SPARANO + MOONEY ARCHITECTURE

ADDENDUM #2

PROJECT:	Caine Lyric Theatre – Fly Loft and Stage Improvements Project	PROJECT NO.	C001541
OWNER:	Utah State University 6550 Old Main Hill Logan, UT 84322-6605	Phone: 435.797.3771 Contact: Thomas Graham	
ARCHITECT:	Sparano + Mooney Architecture 57 West 2100 S Salt Lake City, Utah 84115	Phone: 801.746.0234 Contact: Seth Striefel	
DATE OF ISSUANCE:	April 16, 2025

STAGE LEVEL DEMOLITION
PLANS

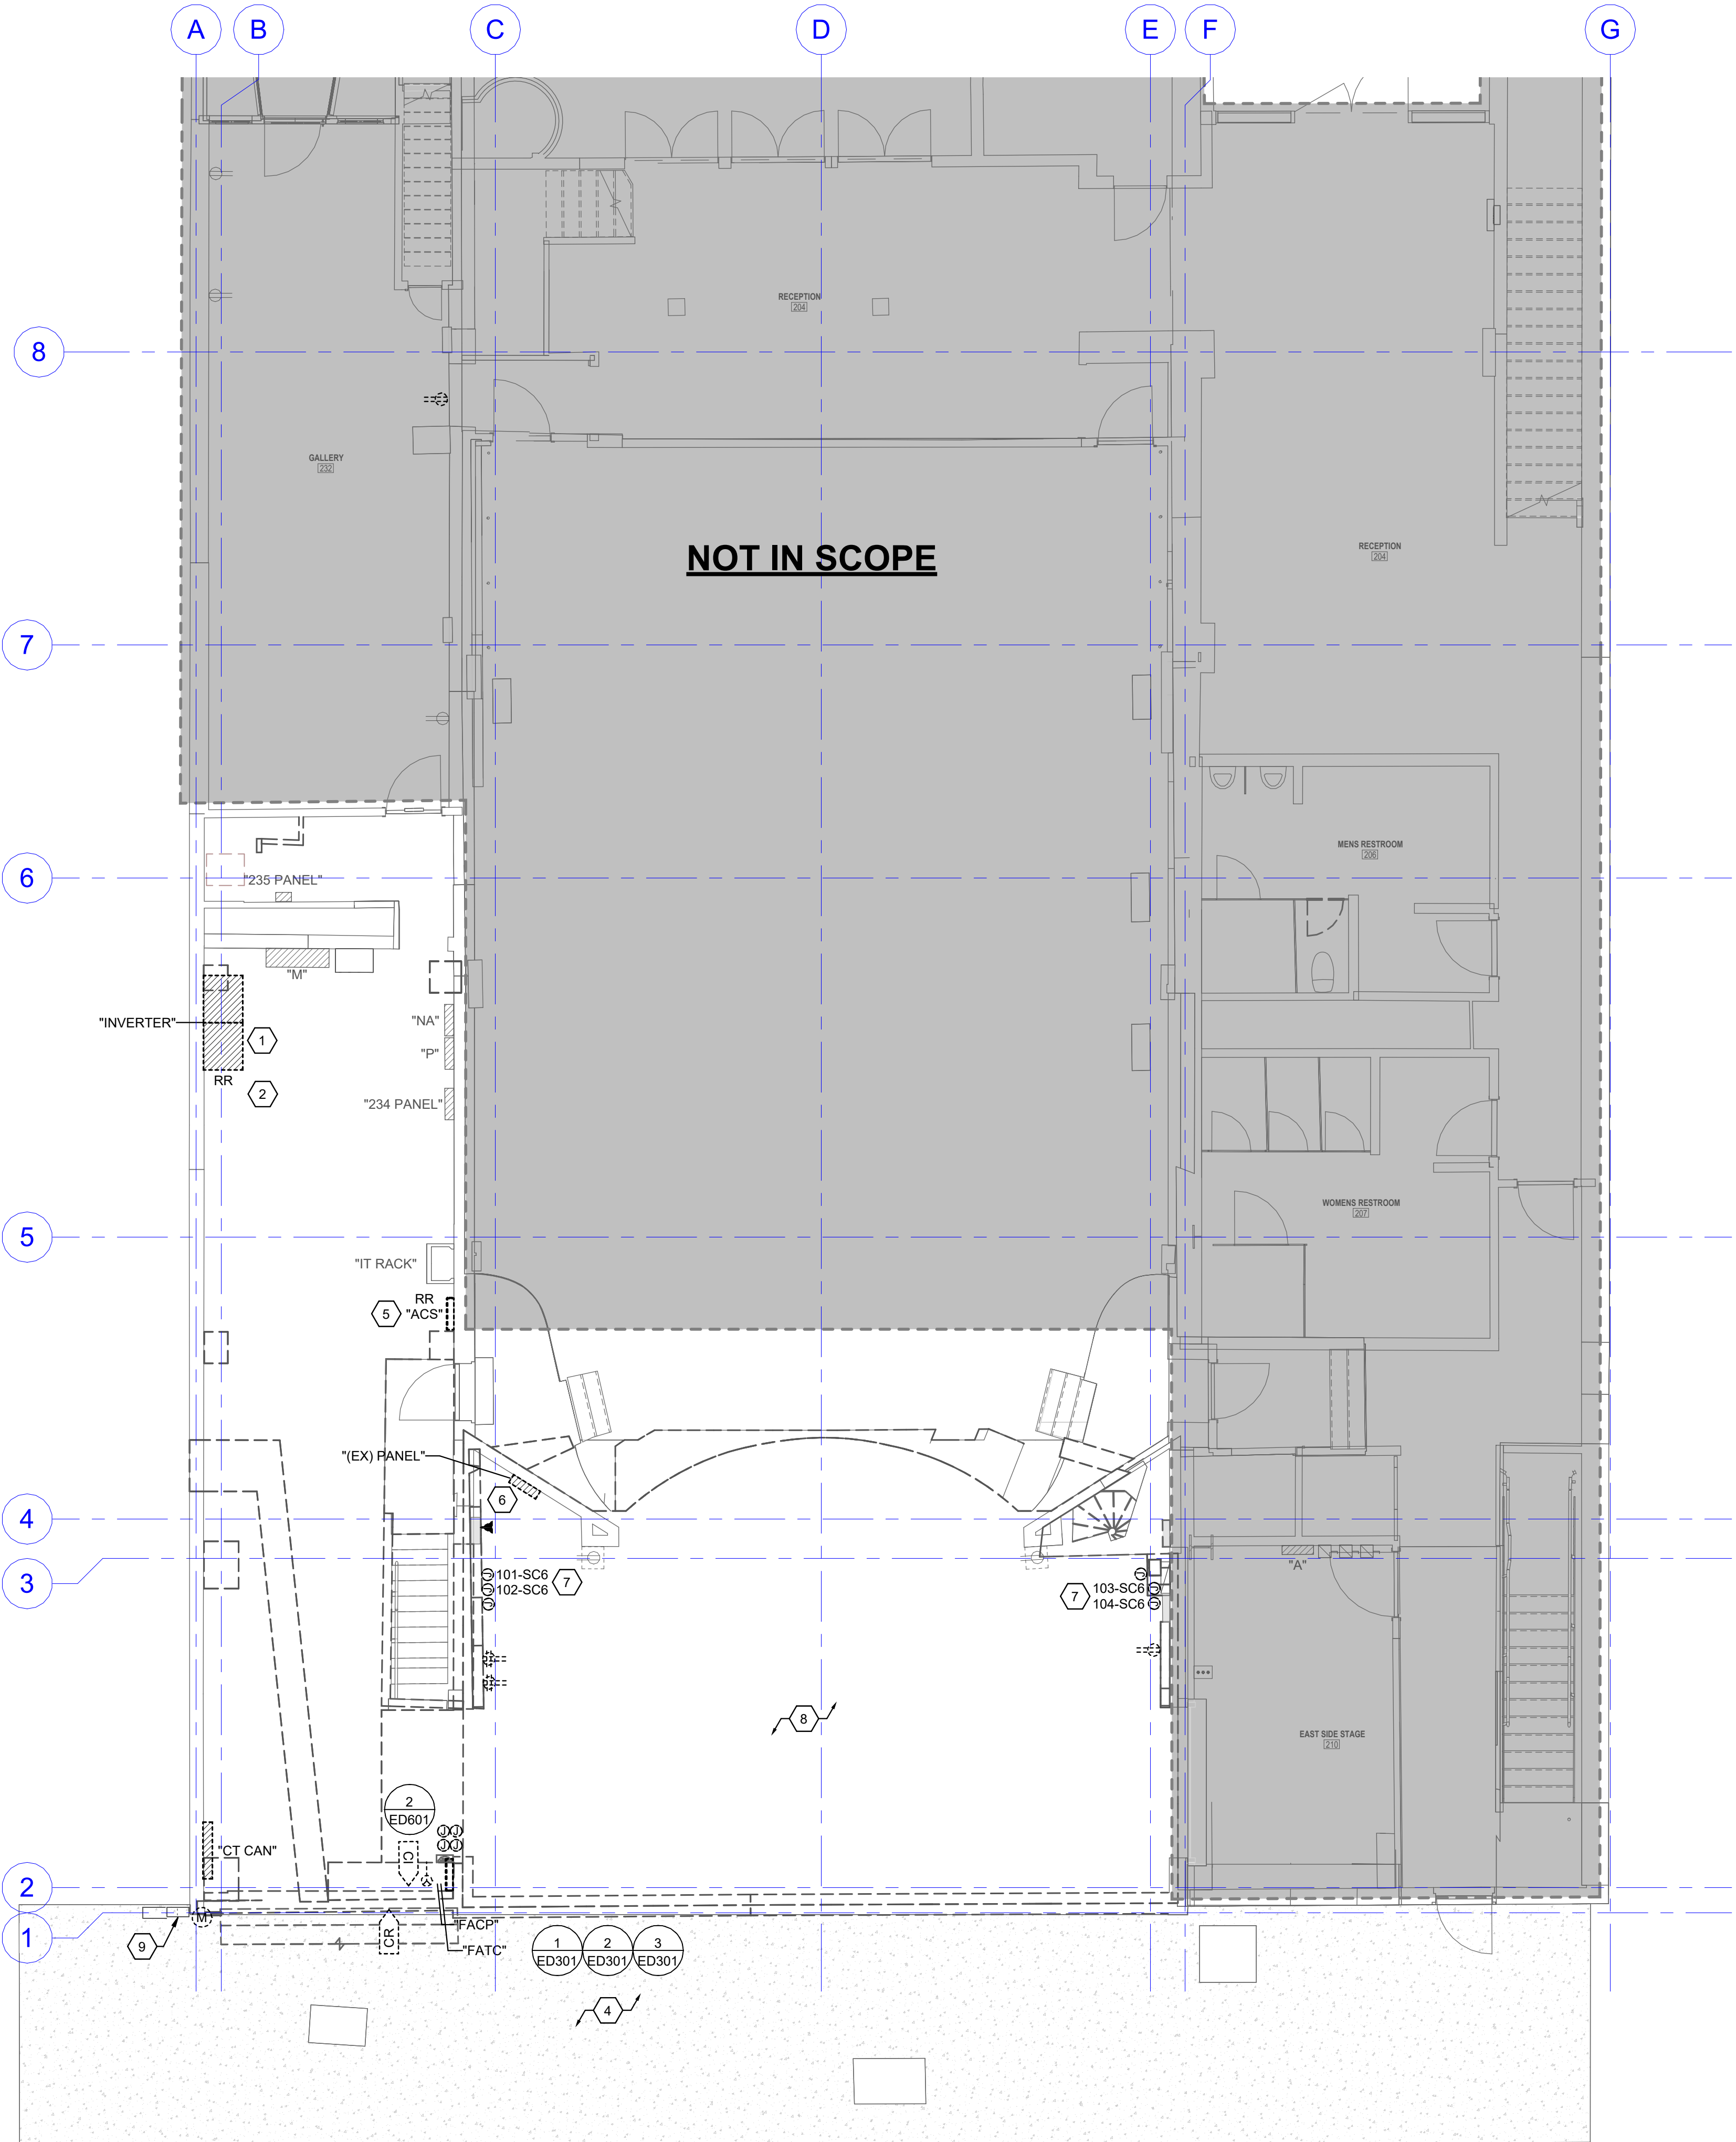
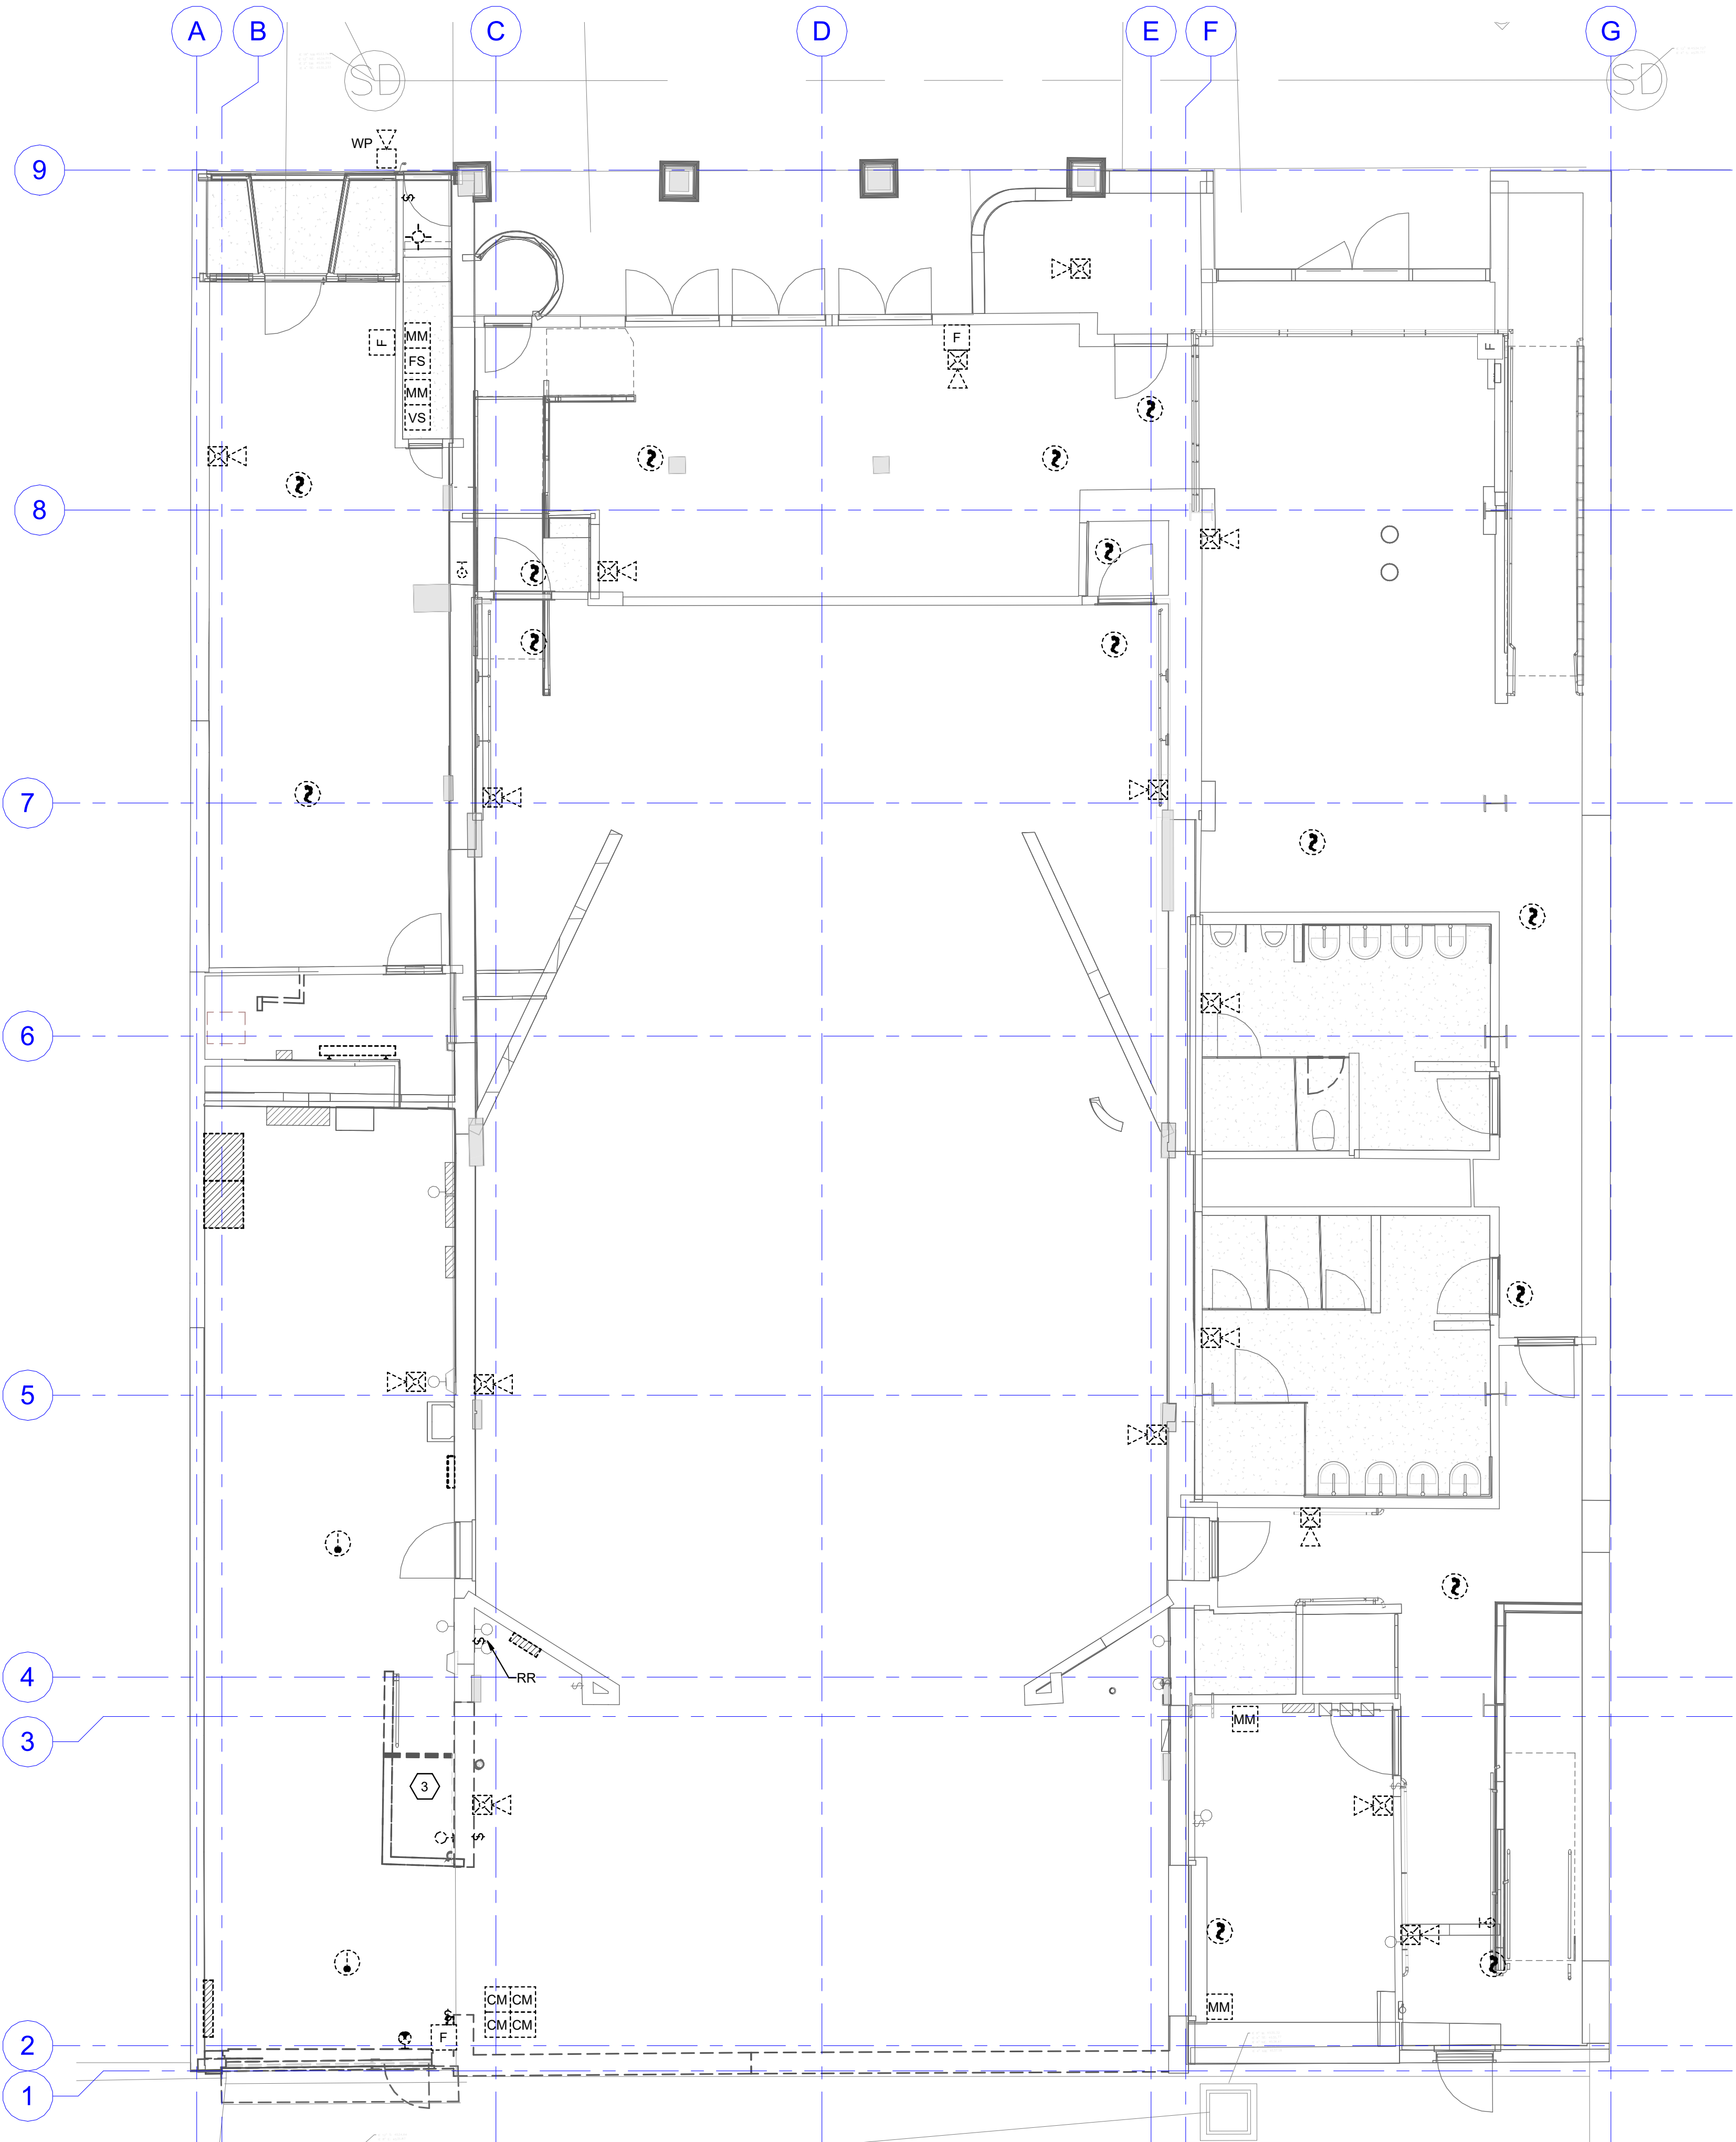
1. ES101 – Relocated pull box “PB1”. See attached sheet.
2. ED101 – Revised sheet keyed note #4. See attached sheet.
3. ED104 – Added j-box for demolition on roof. See attached sheet.
4. ED301 – Revised notes on Existing South Exterior Wall Elevation View3. See attached sheet.
5. EP103 – See attached sheet for the following:
 - a. Added sheet keynote #2.
 - b. Added junction box for IT network.
6. EP651 – Revised Telecom Conduit Riser Diagram. See attached sheet.
